CITY PLANNING COMMISSION
1231 "I" STREET, SUITE 200, SACRAMENTO, CA 95814

APPLICATION: A. Special Permit to construct a second residential unit totaling 640 square feet on 0.22± developed acres in the Standard Single Family (R-1) zone.

LOCATION: 432 Pinedale Avenue

APPLC. NO. P91-205

DIPT OF PLAN
 432 PINE DALE AVE
 APN 226-0151-004
 SCALE 1/8" = 2' 0"
 8-26-91 C.U. Boley
 EXHIBIT A

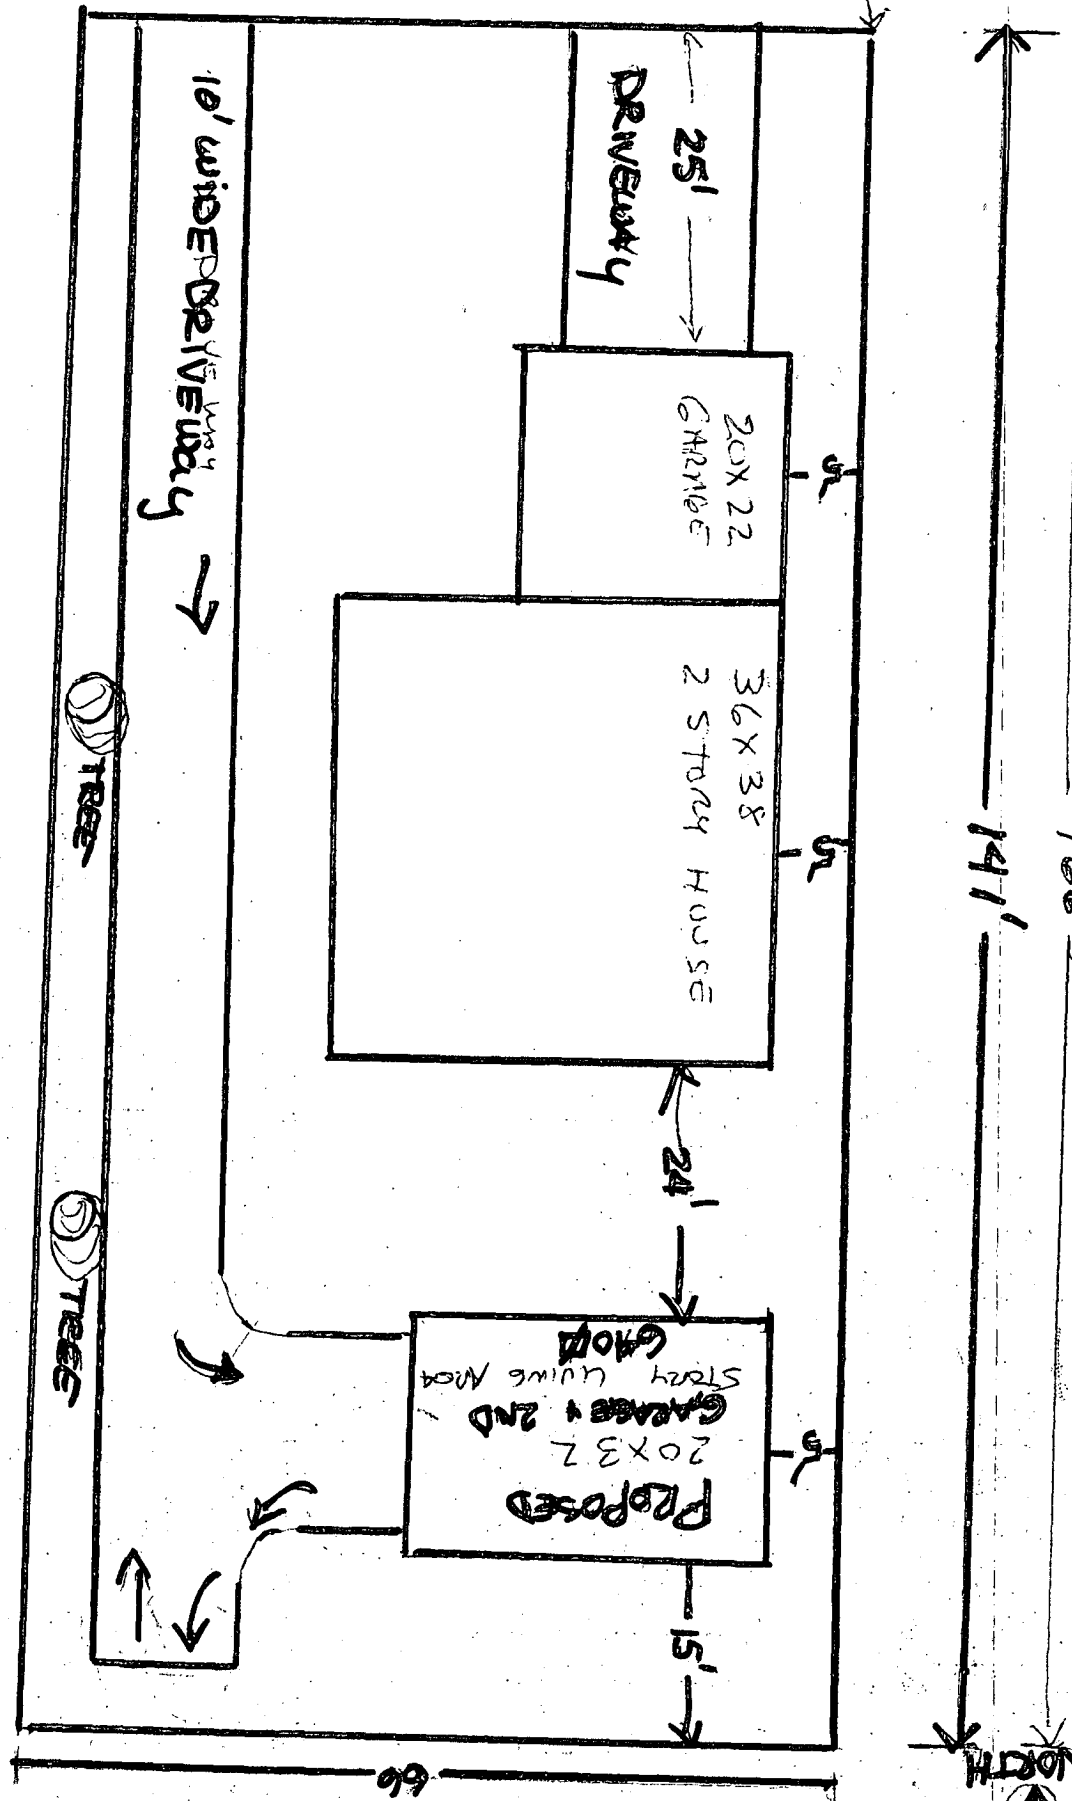
The applicant is locating the second residential unit at the rear of the lot above a proposed two car garage. The submitted site plan indicates driveway access to the second unit off of Pinedale Avenue. A second driveway access, into the garage of the front unit, is located on the east portion of the subject site. The applicant is proposing that a turnaround area be provided at the end of the rear driveway to allow vehicles from the second unit to enter Pinedale forward (see Exhibit A). The second unit is located 15 feet from the rear property line, five feet from the east sideyard property line and 29 feet from the west sideyard property line. The proposed unit will also be located 24 feet from the front residential unit. Staff recommends that the area between the front unit and the second unit be adequately landscaped.

A turnaround area shall be provided on the driveway for the second residential unit in order to allow exiting vehicles to enter Pinedale forward.

STAFF'S REVISED FLOOR PLAN
1st LEVEL

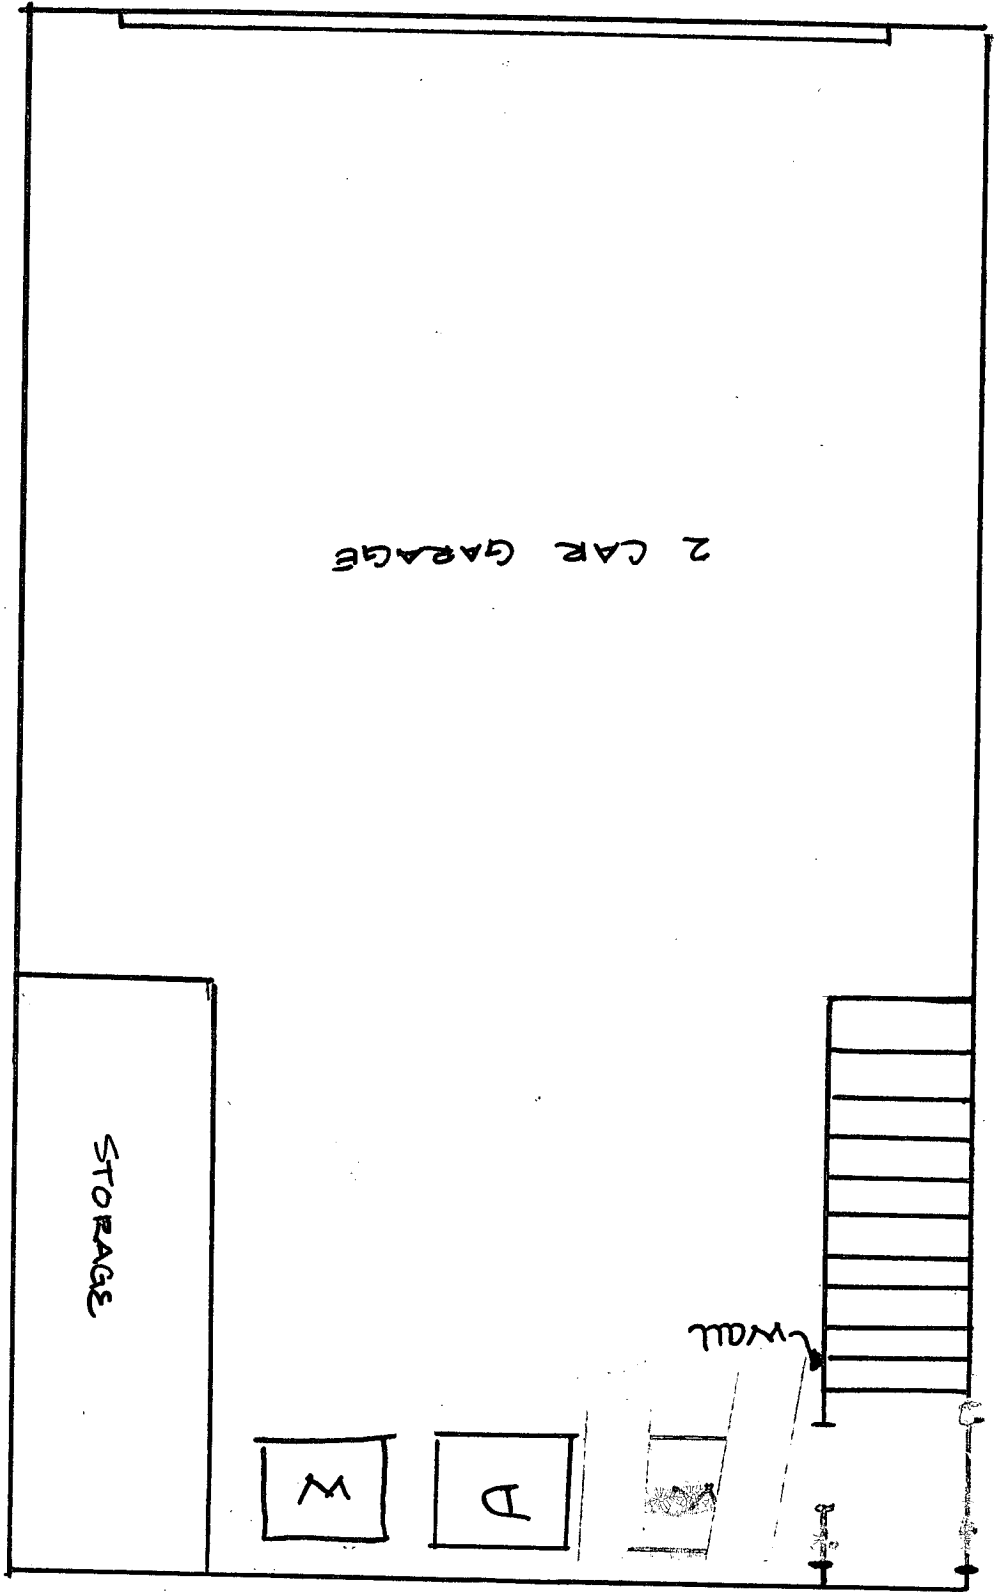
The City's Building Division and City staff reviewed the submitted floor plans and recommends that the first and second level floor plans be modified to comply with Building Codes and the City's Zoning Ordinance. Based on Building Codes, the

primary entrance into the second unit can not be from a garage, therefore, the main entry into the structure should be relocated. In addition, the City Zoning Ordinance prohibits main entrances from the rear yard area. The first level of the unit can not be used as living area. Staff and the Building Division would consider the proposed stairway (33 square feet in area) leading to the second level as livable area and must be separated from the garage area. In addition, combining the 33 square foot stairway area and the proposed 640 square foot second unit would exceed the maximum 640 square feet of livable area allowed in a second unit. Staff, therefore, recommended revised floor plans for both the first level and second level in order to comply with the City's Zoning Ordinance and Building Codes (see Exhibit E and F). The changes included the relocation of the fire wall, the relocation of the main entrance into the structure and the incorporation of the stairway into the living unit thereby removing it from the garage. The applicant agrees with staff's revised floor plans. Staff revised the drawings based on the applicant's drawings and scale.

1. The applicant shall construct the second residential unit per the attached Exhibits E and F. The north and south elevations shall be revised to reflect the alternative floor plans.
2. The first level of the second unit under no circumstances shall be used as living area and shall only be used as a storage/utility and garage area.
3. The yard area between the front unit and the second unit shall be adequately landscaped.
